CUSTOMER ENGINEERING POLICIES AND PROCEDURES

Memo No: 132

SUBJECT: RECTIFIER INFORMATION & LAYOUT

Looking at Rectifier bracket on term block side.
G-15D Ser. #69 on up

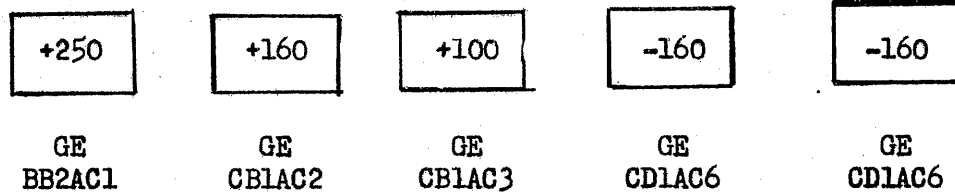
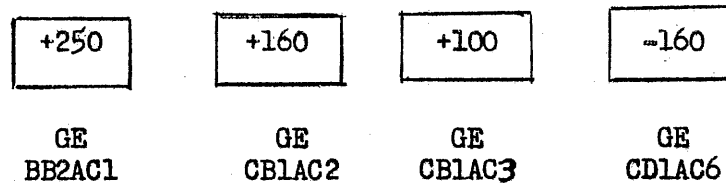
Customer Engineering: Replace field failures of old rectifiers with new type as failures occur.

Effective: 8/21/57 ECO #799
